July 22, 2016

TO: PROSPECTIVE BIDDERS HOLDING PLANS AND SPECIFICATIONS FOR  
TOWN OF WAKE FOREST BID NUMBER 099-075

RE: TOWN OF WAKE FOREST WAYFINDING SIGNAGE FOR PARKS & GREENWAYS, PH. 1  
ADDENDUM NO. 1

**2** E1 & E2 CABINET BACKLIGHT DETAIL  
 SECTION SCALE: 1/4"=1'-0"

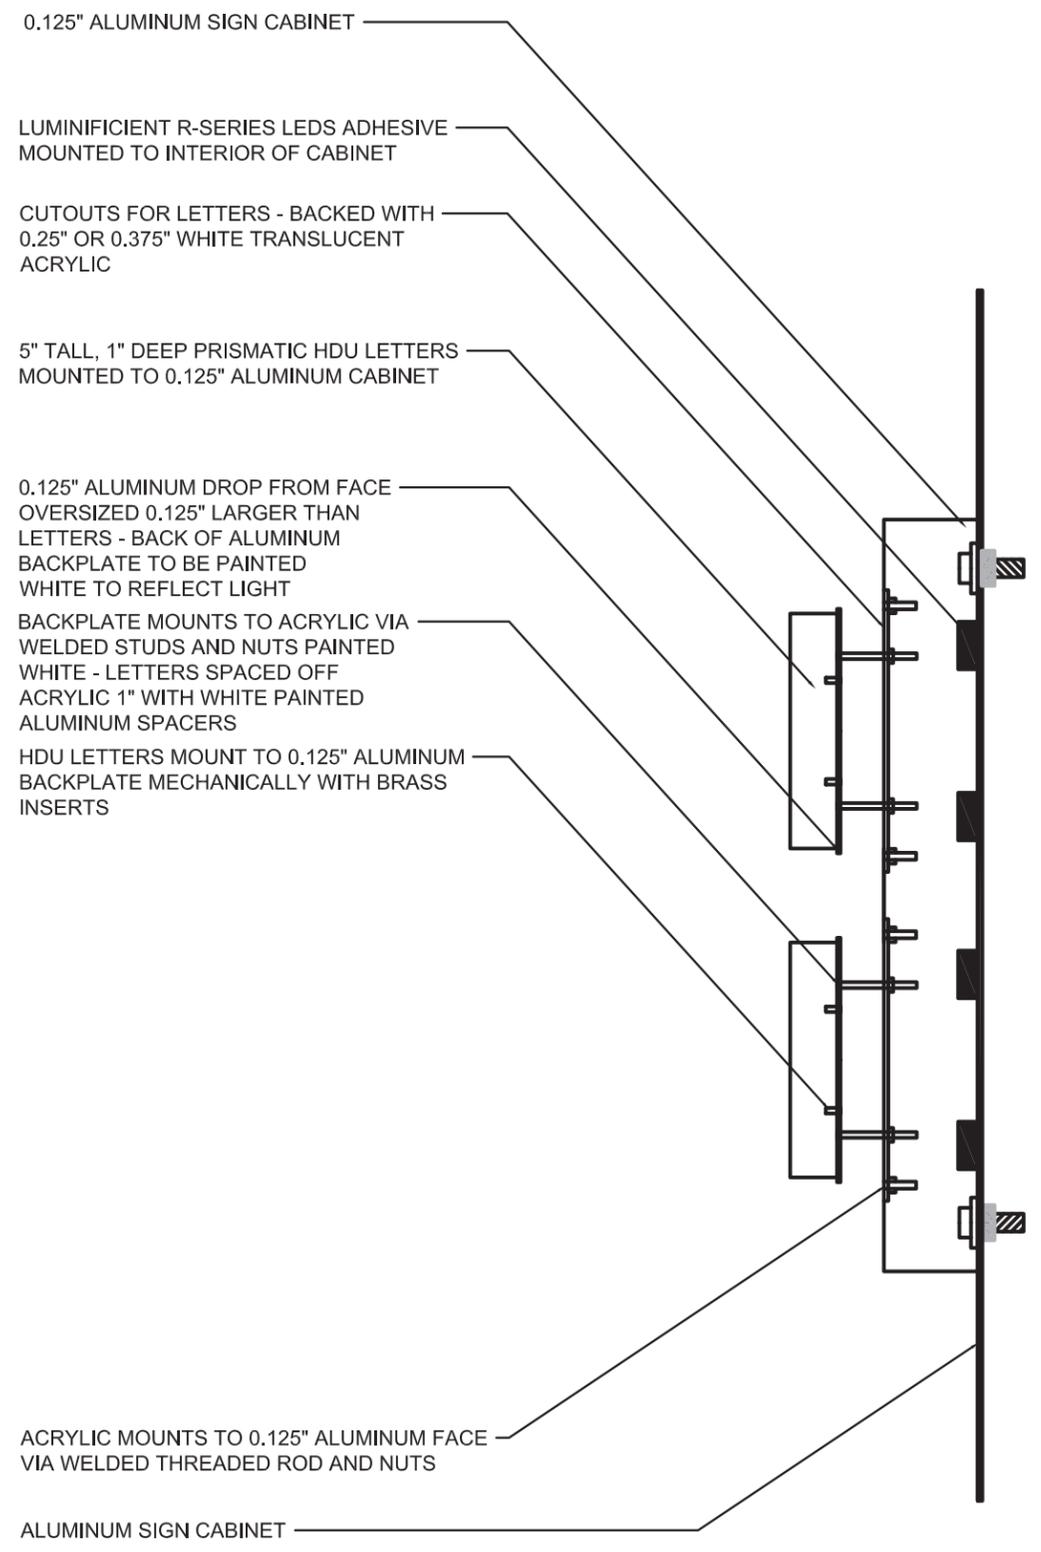
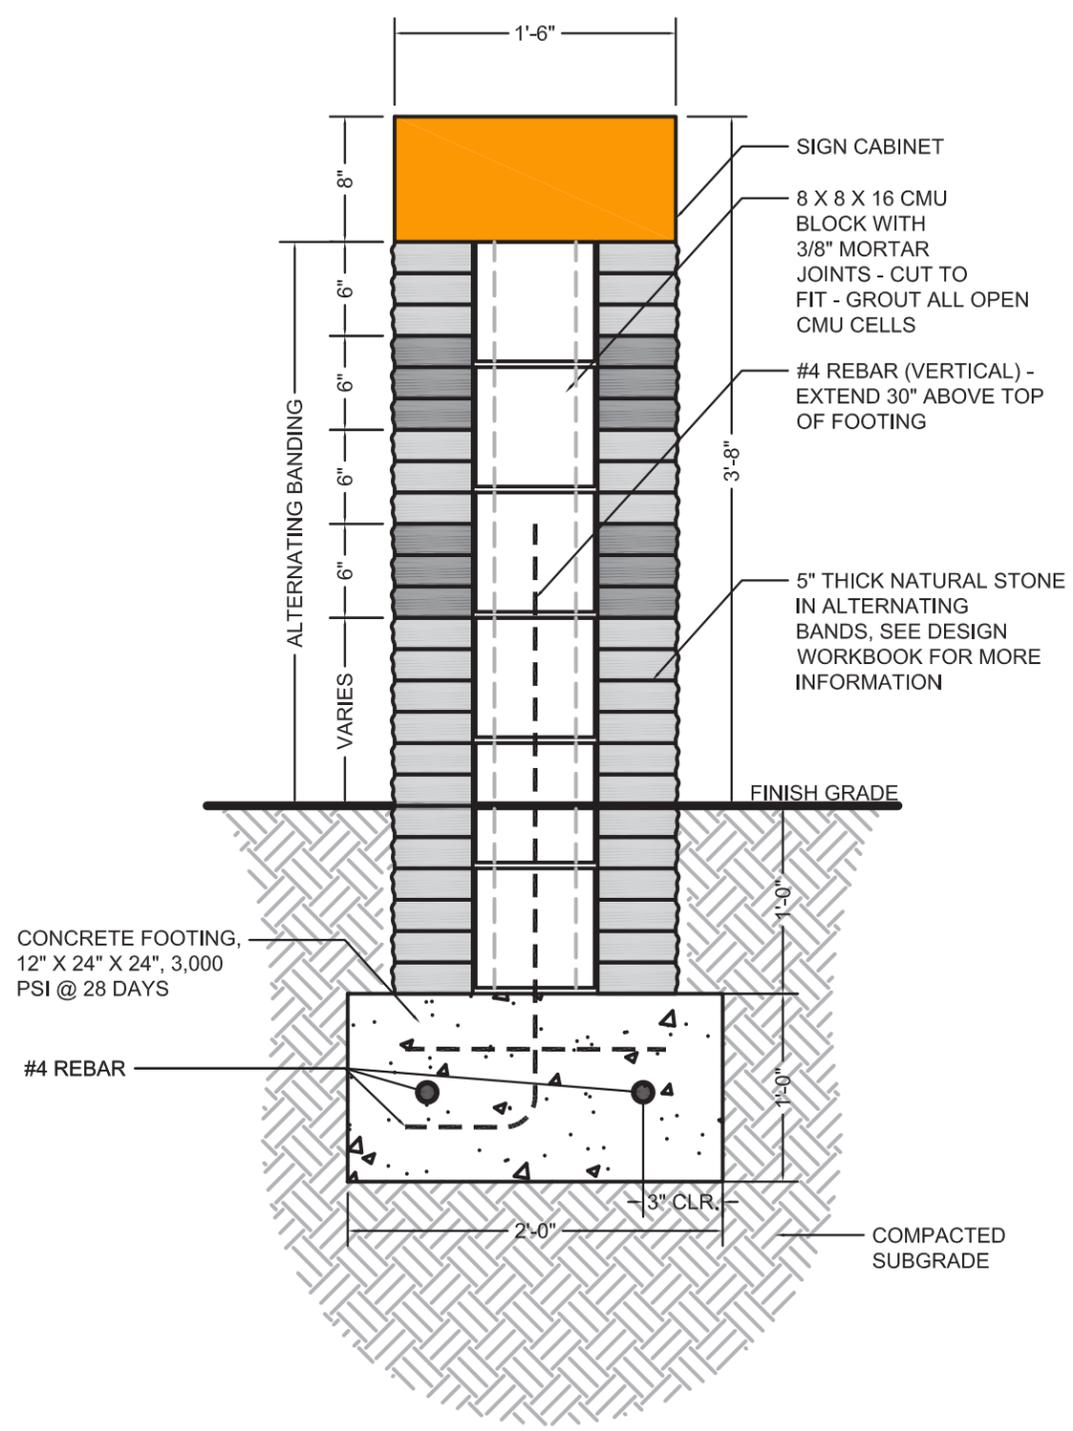
1. **Question:** On Sign E1, what part of the sign is illuminated? The plans show the park name and the symbol section are illuminated cabinets, but the design workbook shows opaque black vinyl and painted sign cabinet. Please clarify.

**Response:** *The park name should use 5" tall, 1" deep prismatic HDU letters. Letters should be spaced off of the 0.125" aluminum raised panel and should be illuminated through cutouts. Cutouts should be backed with white translucent acrylic. See attachment (park entrance sign (E1) illumination detail) for more information.*

3. **Question:** On Sign MM1, will this sign have a CMU interior structure? If so please provide details and/or drawings.

**Response:** *It is anticipated that the Mileage Marker (MM1) will have a CMU interior structure. See attachment (MM1 Pier Detail) for more information.*
